AGC/WSDOT Structures Team – Meeting Minutes (March 2, 2023)

AGC/WSDOT Structures Team – Meeting Minutes April 13, 2023

AGC/WSDOT Structures Team – Meeting Minutes May 25, 2023

AGC/WSDOT Structures Team – Meeting Minutes (September 14, 2023)

4. Project Review - US2/SR9 Bunk Foss Realignment Alternative (WDFW ID#932428)

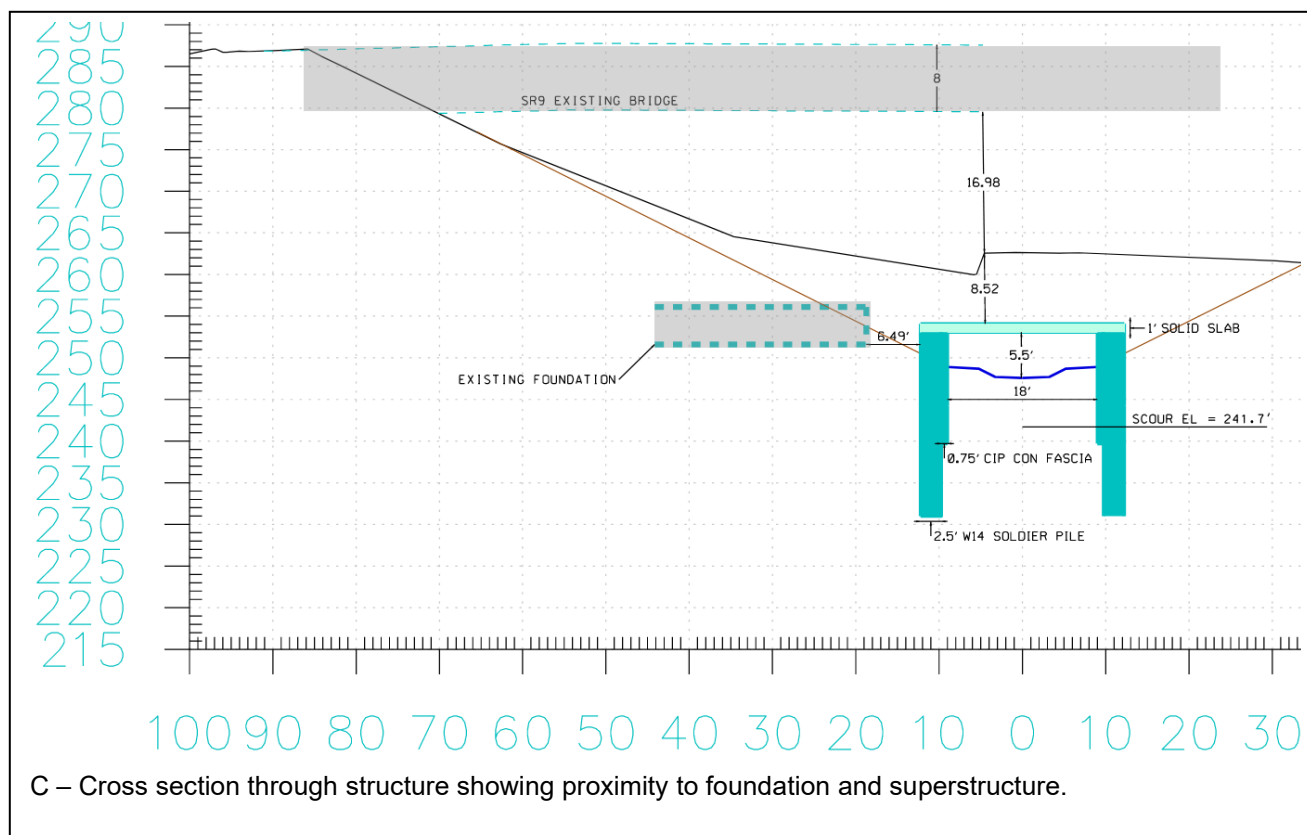
Vertical clearance to construct the soldier piles under the SR9 bridge is a concern for the design team. Clearance is about 17 feet, with excavation to the lid that clearance can be increased to about 25 feet, but that is probably not enough clearance to avoid splicing soldier piles. The Structures team asked why this had to be a soldier pile system and what prevented this from being a precast buried structure? Vincent indicated it was the proximity of the abutment footing and soldier piles were selected so that they didn't need to install a shoring wall in addition to the structure. The selected structure type was self-shoring. It was pointed out that the footing conflict was only for a limited length and that shoring for the footing could probably be used enabling a precast structure to be used.

The Structures team also asked about changing the alignment and getting the new structure out from under the bridge. The design team acknowledged that they were considering that, but the goal was to minimize the number of crossings. Because of the diamond I/C additional crossings under the ramps would be needed. The structures team pointed out that they could use much smaller structures on an alternate alignment and could possibly construct the ramp crossings under a long weekend if precast buried structures were used. Crossing US2 could still occur using the staged concept presented with traffic shifted to the north, build the south half, shift traffic over the newly constructed southern half, and finish the constructing of the north half. Crossing SR9 may be more problematic though due to the fill height and proximity of the SB SR9 to WB US2 ramp terminal and intersection with Bunk Foss Rd.

The conversation with the contractors eventually went to them recommending a cast in place, buried, 4-sided structure, especially if there was enough room to shift traffic for the duration of time it would take to construct one half of a box structure. The recommendation was made because handling forms would be much easier with the limited headroom than handling precast units or installing soldier piles. With the option to shift traffic, time constraints associated with concrete curing may be less of a problem than is often the case for other fish passage projects.

One option that also was presented was using a corrugated metal plate structure which could be assembled in place using small equipment and hand tools rather than a CIP box or precast buried structure. Nobody really explored the option that was suggested.

In summary, the project as presented is constructible. The soldier pile walls will require specialized low clearance headroom equipment and the soldier piles may require splicing. The construction will be slow and the structure will be very expensive with the option presented. A precast buried structure may be feasible, but there would definitely be additional costs associated with temporary shoring near the bridge footing and along the centerline of US2 for the staged construction. An additional shoring wall will be required to retain some of the end slope fill from the North abutment of the SR9 bridge due to the need to shift traffic toward that abutment. That shoring wall is likely needed for all options that shift US2 traffic northward. If the project has the time, a CIP structure rather than a precast structure would drastically reduce the needed equipment and make construction under the bridge much easier. A longer wider structure could actually save money too, and the wingwalls could be much smaller.
